OAKLEY SQUARE DEVELOPMENT LTD

REVISED PROPOSED SECTION B-B &
ELEVATION 6

1.200 @A5	2100	SC	SC
DRAWING NO 2115-PL-118		DATE 13.06.2019	REV C

PROPOSED SECTION B - B
1:200 @A3

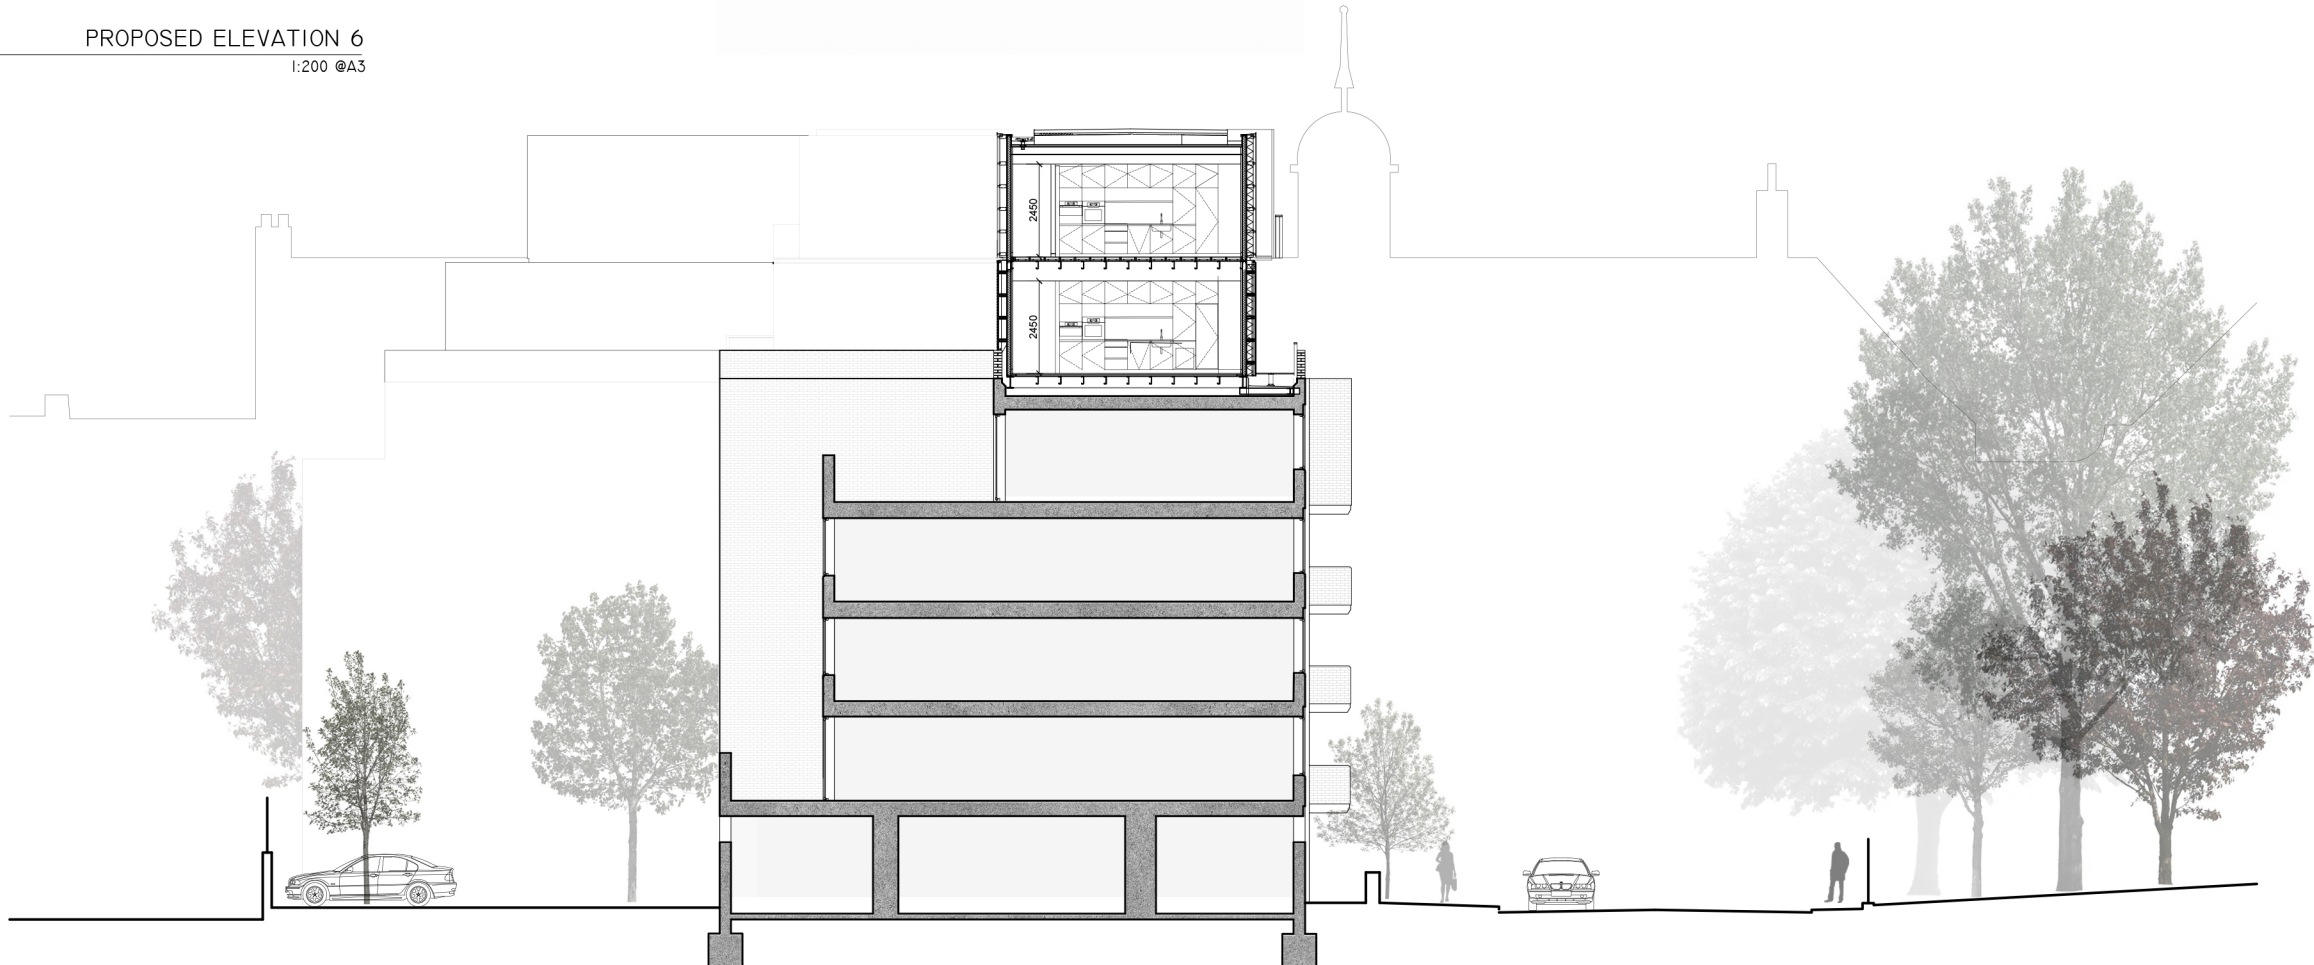
C - Splay panel to the Juliet balcony increased and window head reduced to align with ceiling
